ADDENDUM NO. 1

**Administration Building Renovation Re-bid
Compton Community College District**

tBP Project. No. 20987.00

tBP/ARCHITECTURE

owner
IBP project number: 20987.00
file name: CC_Admin_Remodel_Central.rvt
drawn by: Z. WEN checked by: P.M.
date: 8.29.2019
rev: date: description:
1 08/07/2023 ADDENDUM 1
drawing title:
FLOOR PLANS - RENOVATION
drawing no.:
A1-1
drawing of

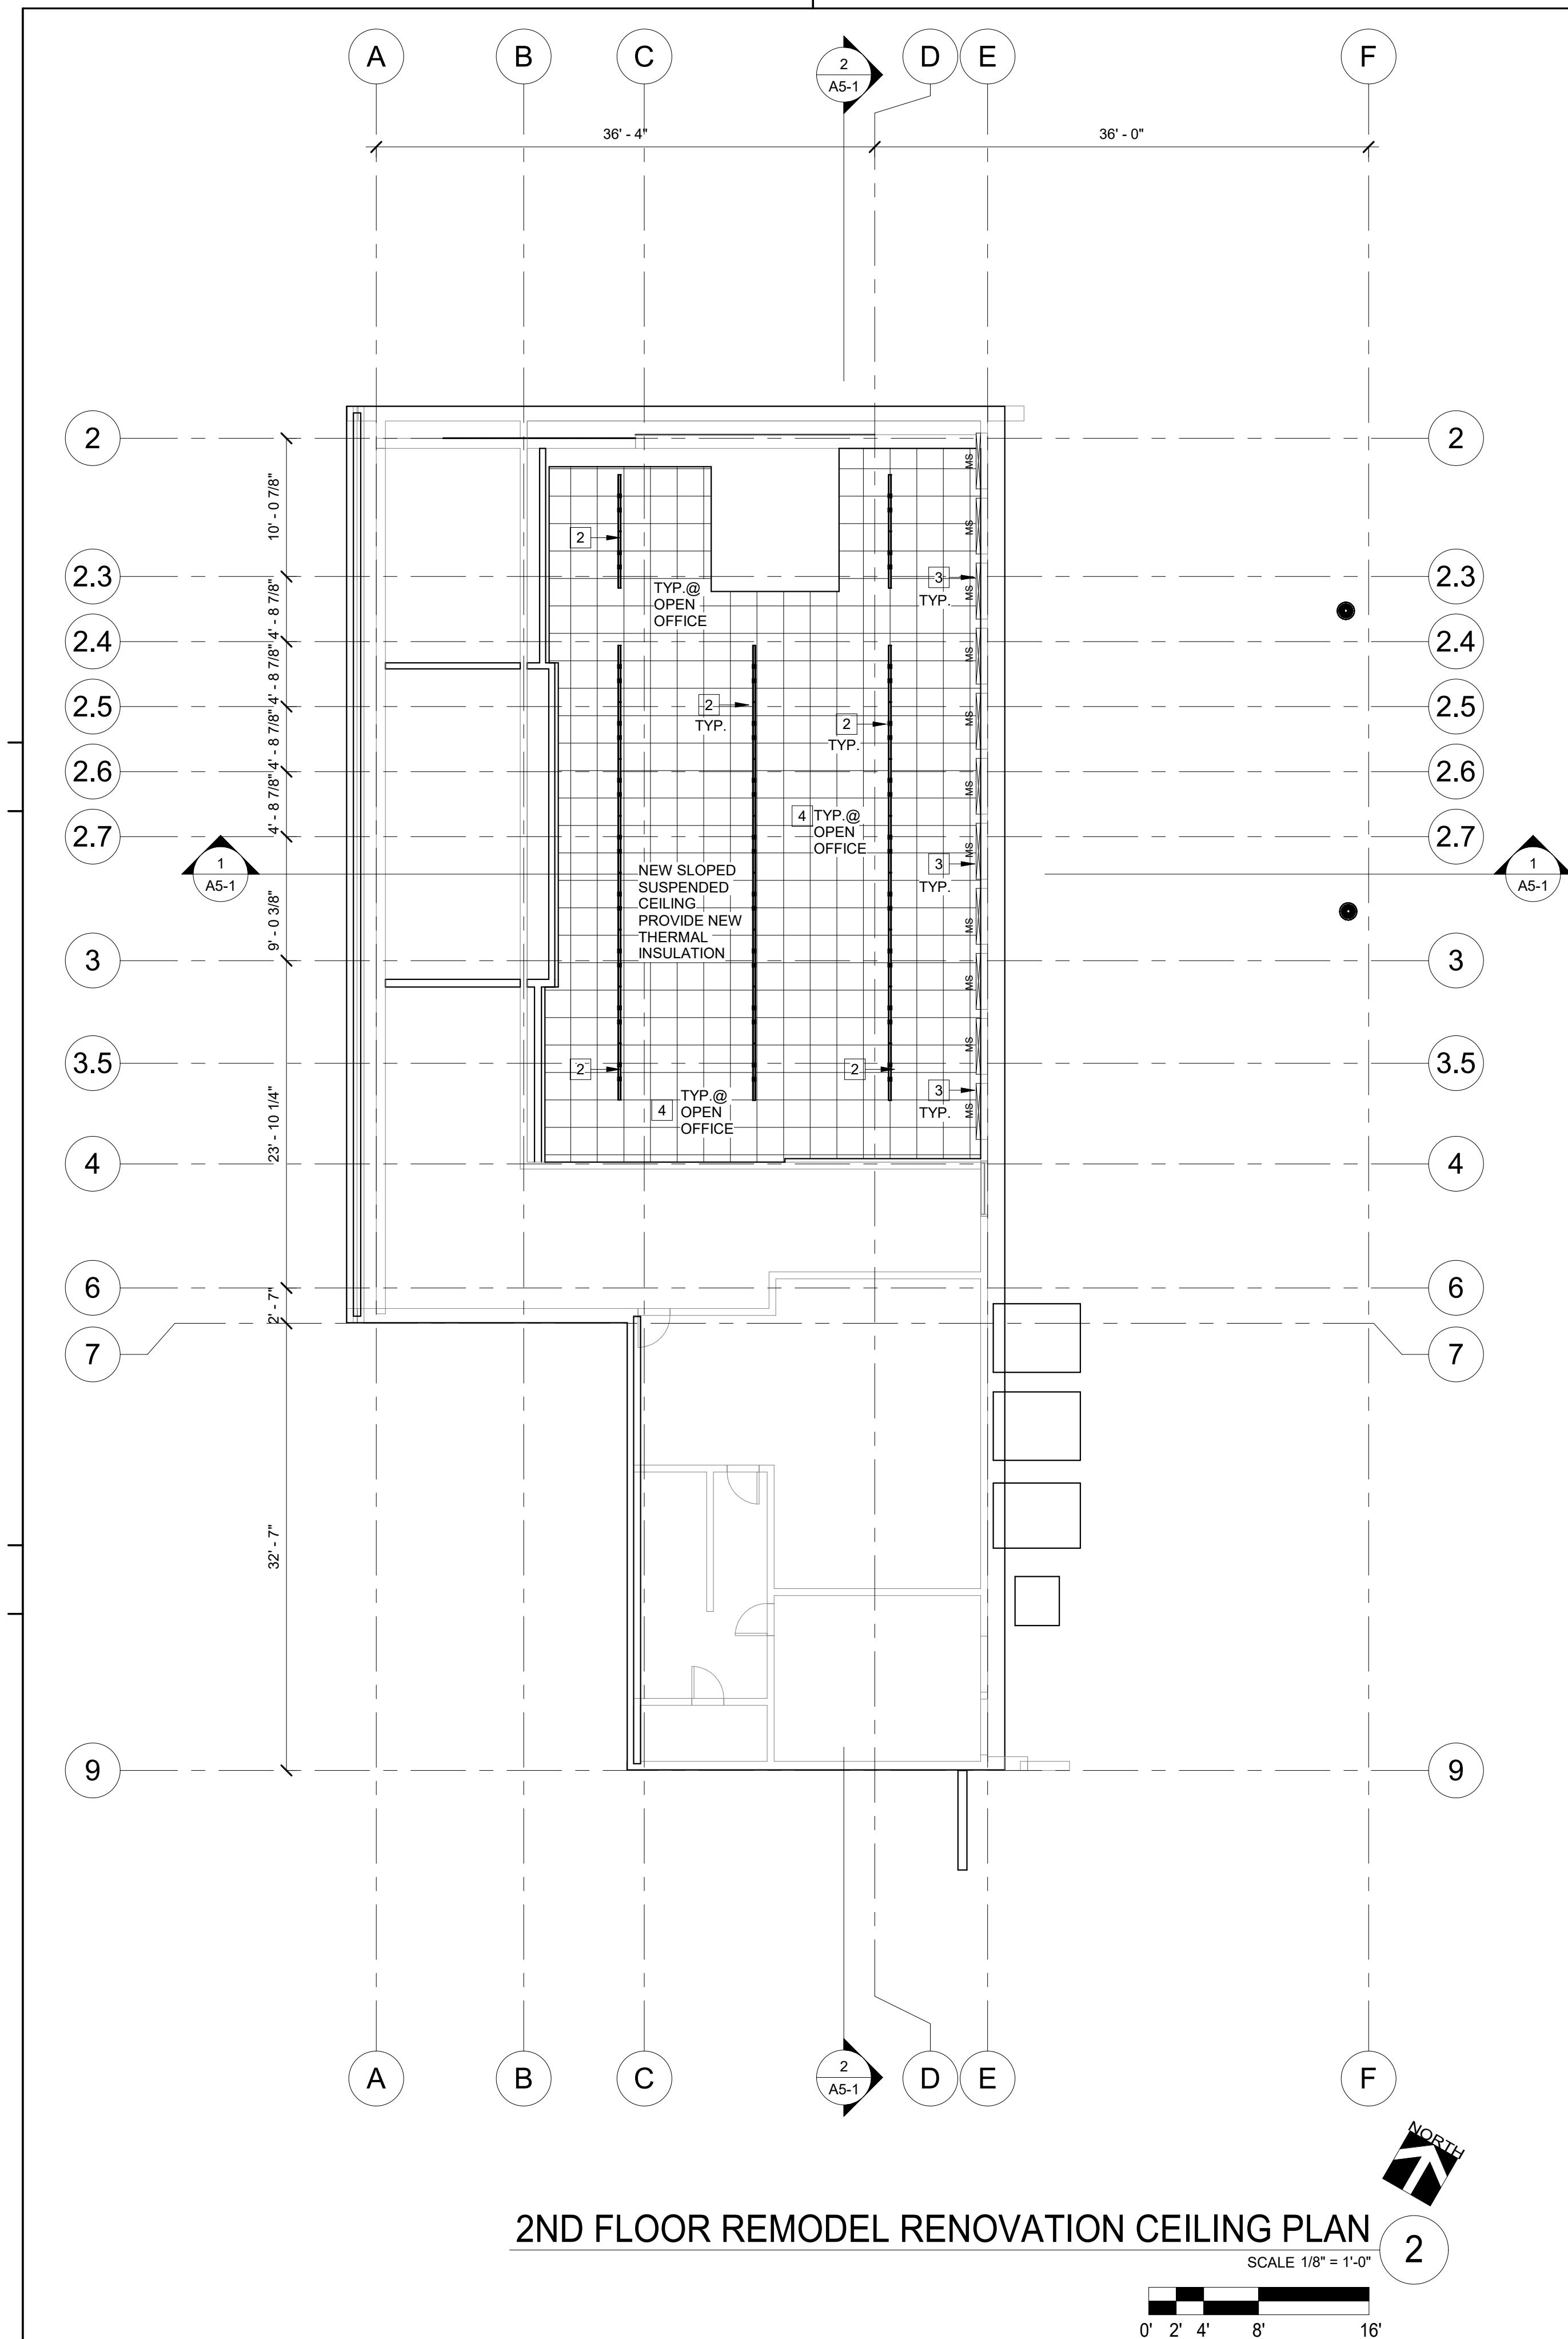
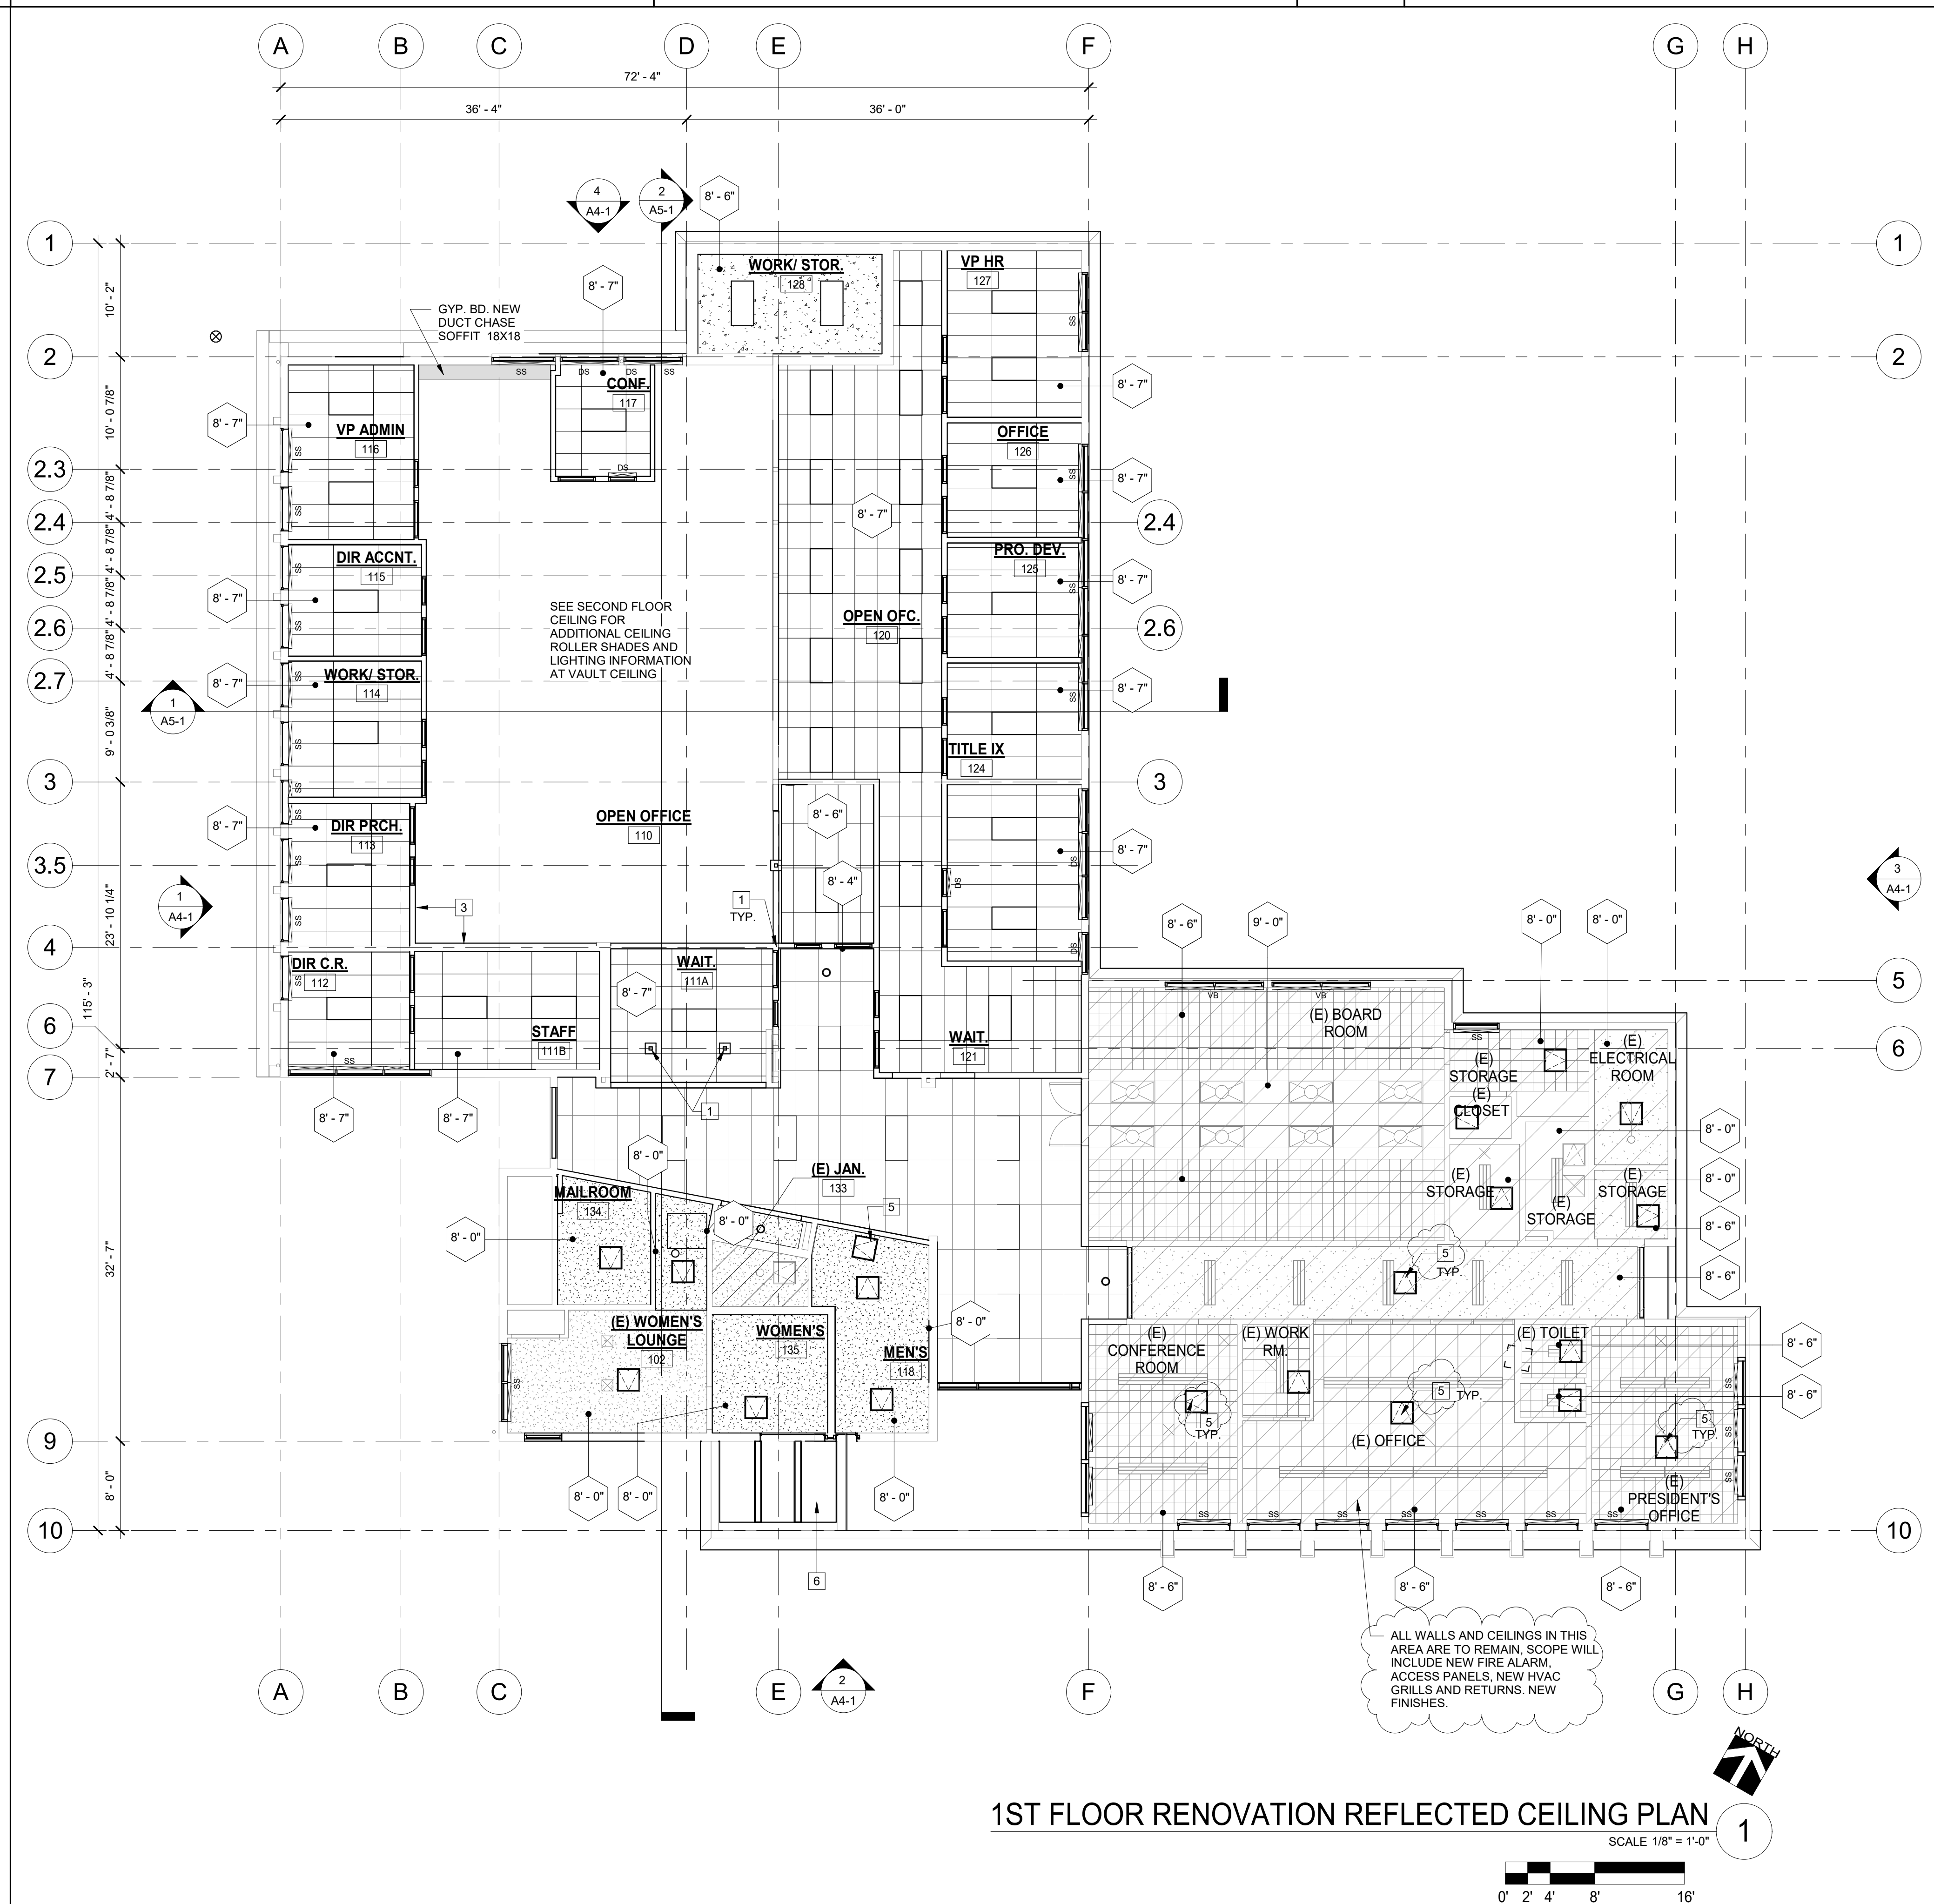
5. **Revised SHEET A1-1 FLOOR PLAN RENOVATION**

- a. Corrected general notes and key notes to clarify ambiguous scope notes.
- b. Added two new doors to scope at Electrical Room 146 and Storage 145.
- c. Corrected wrong detail reference at ext. window at grid line "F" and at gridline "7".
- d. Relocated new high/Low drinking fountain to alcove where the telephone booths are being removed.
- e. Added 6" furring wall at Mailroom 134 for Electrical panel re-location.

- f. Added new window AL-22 to the scope.
- g. Added keynotes reference and notes #s 22, 23, 24, 28,31
- h. Interior wood doors' frame to be Hallow Metal instead aluminum.
- i. Lobby floor to be patched and prepared to receive new finish.
- j. Added door 128 to the hardware scope.
- k. Identified backing in wall for shelves and cabinets.
- l. Removed 7 windows from scope at south elevation of the building.
See attached revised Full size sheet identifying revisions included as part of this addendum.

drawing title:
ROOF PLAN - RENOVATION
drawing no.:
A3-1
drawing of

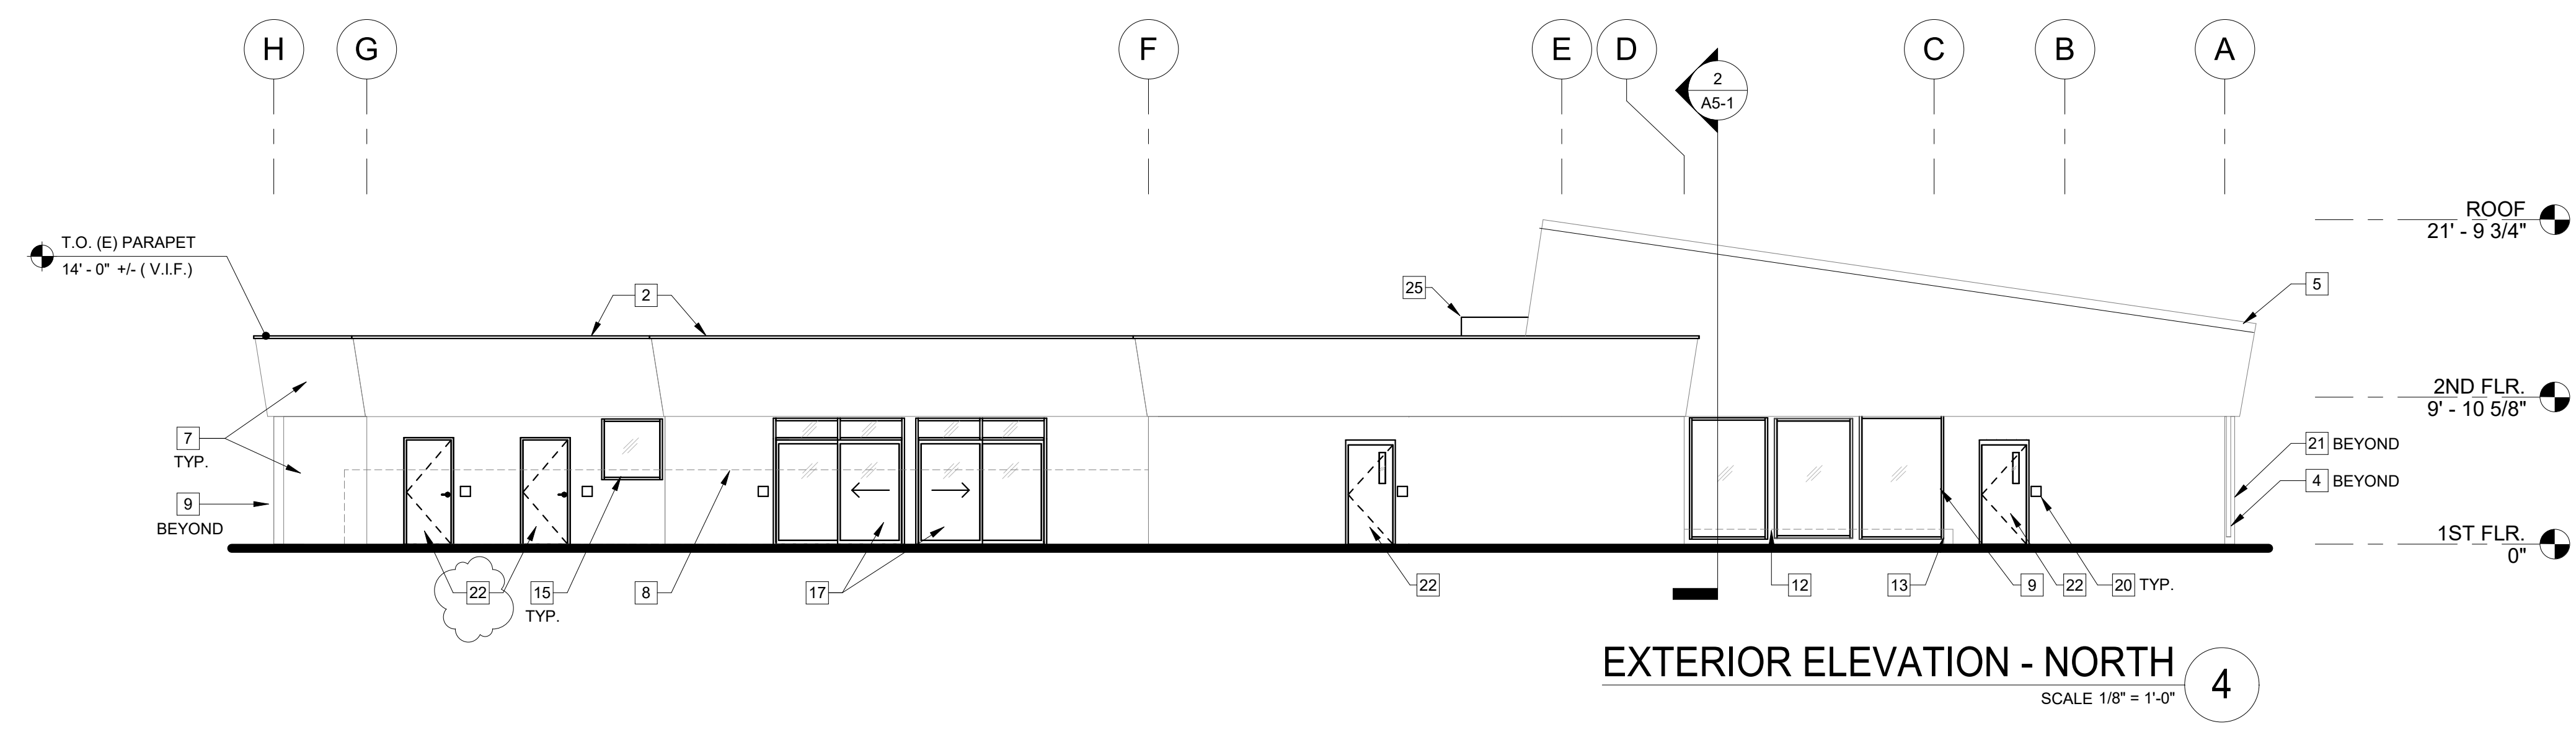
7. Revised SHEET A3-1 ROOF PLAN RENOVATION

- a. Corrected general notes and key notes to clarify ambiguous scope notes.
Added reference details to notes.
See attached Full size sheet identifying revisions included as part of this addendum.
